**Comments of the California Wind Energy Association on
CPUC and ISO 50% RPS Special Study for the
2016-2017 Transmission Planning Process**

July 5, 2015

The California Wind Energy Association (CalWEA) recommends the following changes to the Special Study as described during the June 20, 2016, public call and related materials:

PC-21 Heavily Utilized Paths

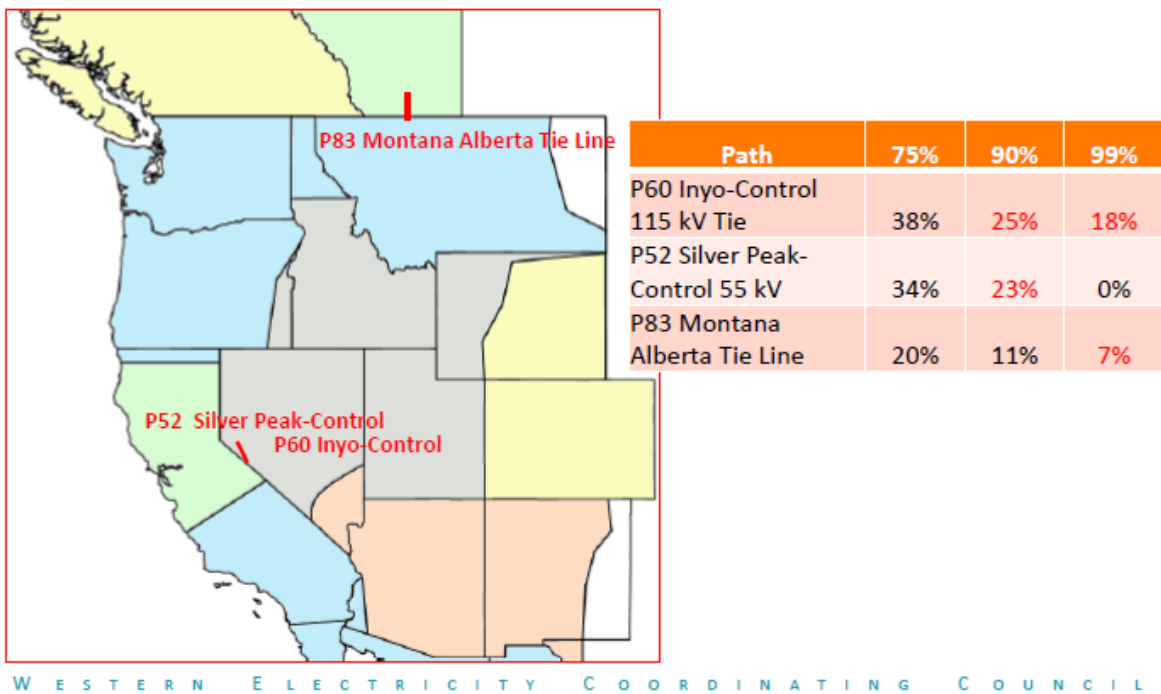
import into California. (See PC-21 slide reproduced below.) Specifically, the following can be gleaned from PC-21:²

- The retirement of over 6,000 MW of coal units that are already scheduled to occur by 2024 will enable approximately 3,500 MW of wind energy and 1,800 MW of solar to be accessed through dynamic transfer (DT) arrangements with the CAISO (or via an expanded CAISO) without any transmission upgrades.³
- The retirement of 16,000 MW of coal capacity (about half that now operating) would enable 9,600 MW of wind and 4,800 MW of solar to be dynamically scheduled with very modest transmission upgrades.⁴

This WECC case was not necessarily an optimal one; it was constructed in a certain way for whatever reasons that are not explained on the slides. As part of the Special Study, CAISO and CPUC should develop an optimal level of WECC renewables that considers WECC coal plant retirements and the ability to dynamically schedule renewables into the CAISO, or directly interconnect these renewables in an expanded CAISO.

⁴ Slide 11 from the October 2015 WECC presentation shows that just three transmission paths become constrained under PC-21; CalWEA believes these paths can be relatively easily and cheaply upgraded.
